Product Change Notification / CENO-02KHGL616

CCB 5240 Initial Notice: Qualification of MTAI as a new final test site for selected SST39LF0xx and SST39VF0xx device families available in 32L PLCC (11.5 x 14 x 3.37) package.

CCB 5240
Pre and Post Change Summary
PCN #: CENO-02KHGL616

Tube - Drawing

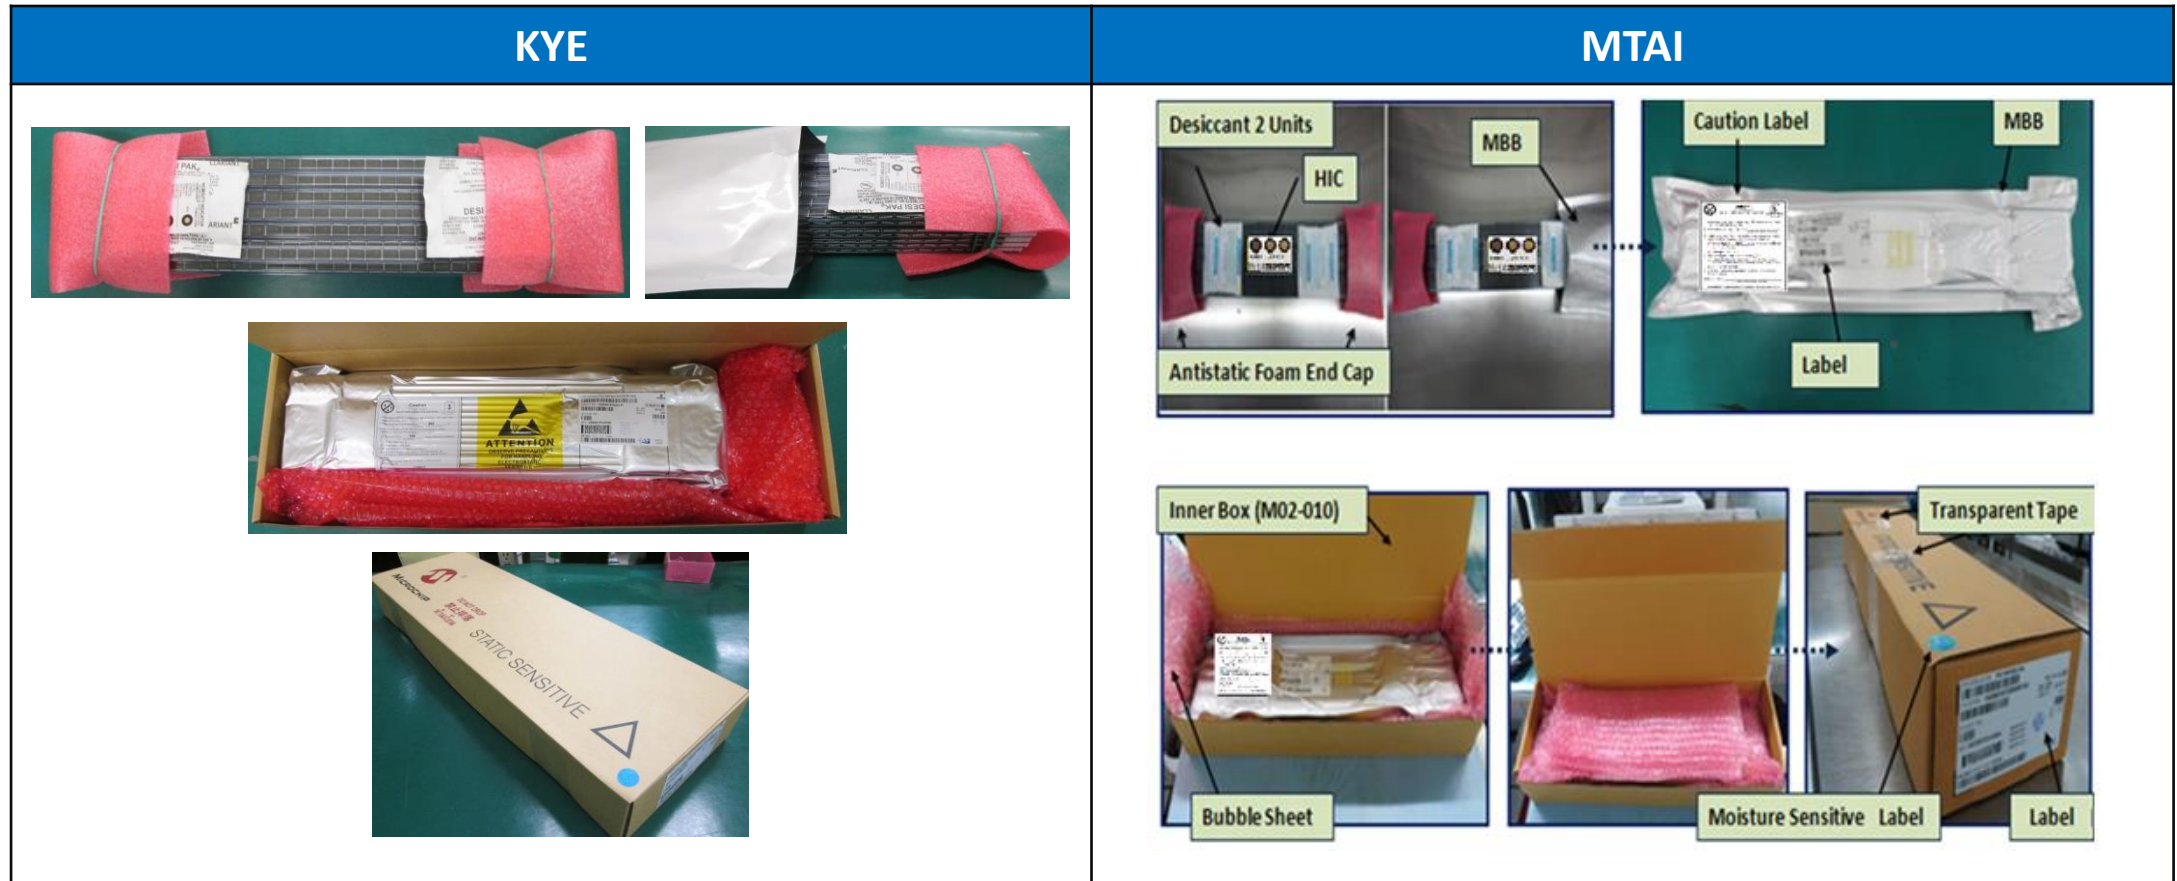
Tube	Final Test Site	Tube Length (in)	Dimension A (in)	Dimension B (in)	Tube Color
Assembled at LPI	KYE	19.4	0.53	0.174	Clear
Assembled at GTK	KYE	19.4	0.53	0.174	Clear
Assembled at MMT	KYE, MTAI	20.045	0.510	0.150	Clear
